N9937A-01

S E R V I C E N O T E

N9937A - FieldFox Handheld Analyzer

Figure 1: No sidebands issue

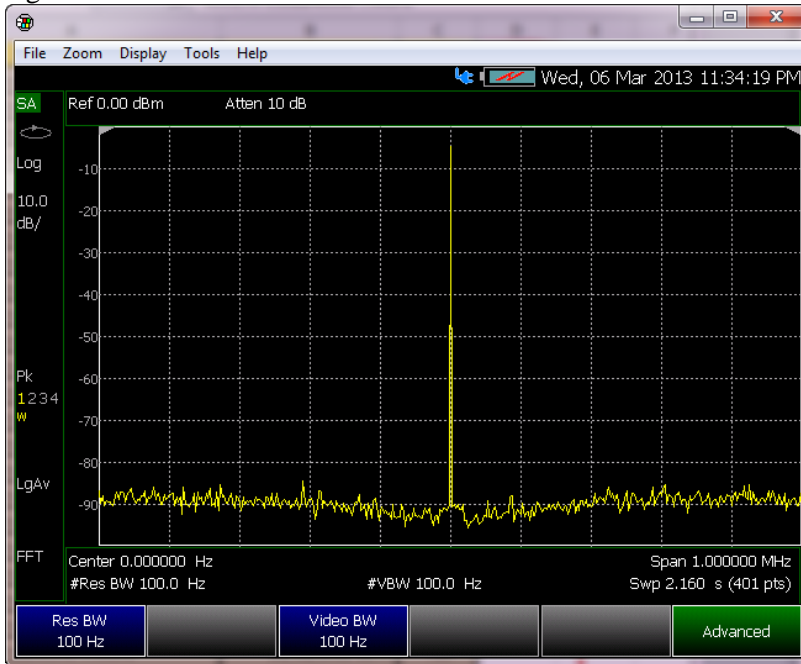
RF board earlier than Rev 7 may have sidebands issue due to oscillation by the voltage regulator. After it is fixed by replacing a new inductor, the RF board revision header will be updated to reflect the change.

Figure 1 shows a good RF signal, and Figure 2 shows FieldFox with sidebands issue.

Affected FieldFox are required to send back to Agilent factory for RF board reliability enhancement. The RF board revision header will be updated to reflect the change. Test and Adjustment shall be done before shipping back to customer.
